Product Advisory

Change Description:

Addition of dry film solder resist in substrate manufacturing

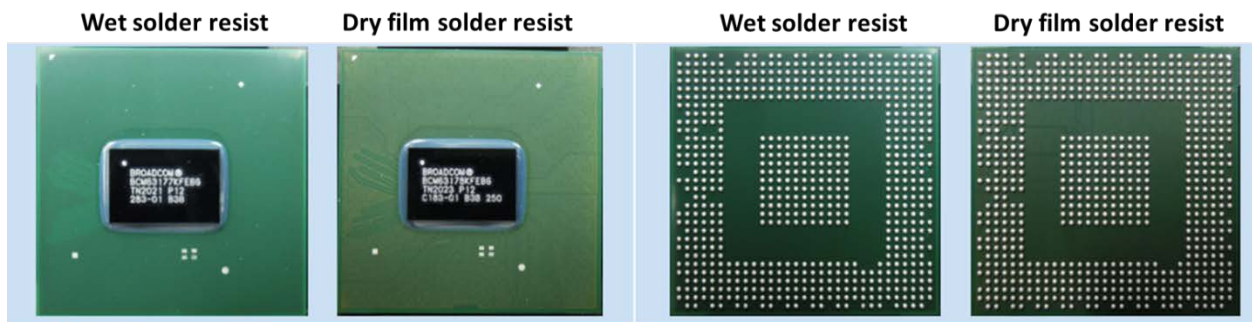
Addition of dry film solder resist to current wet solder resist process. Dry solder resist film is translucent, and is currently used in production on other Broadcom high volume products. Dry solder resist film Form, Fit and Function are identical to the wet solder resist currently used, except for the cosmetic difference. Use of the dry solder resist film has no impact to customers SMT process. Example shown below:
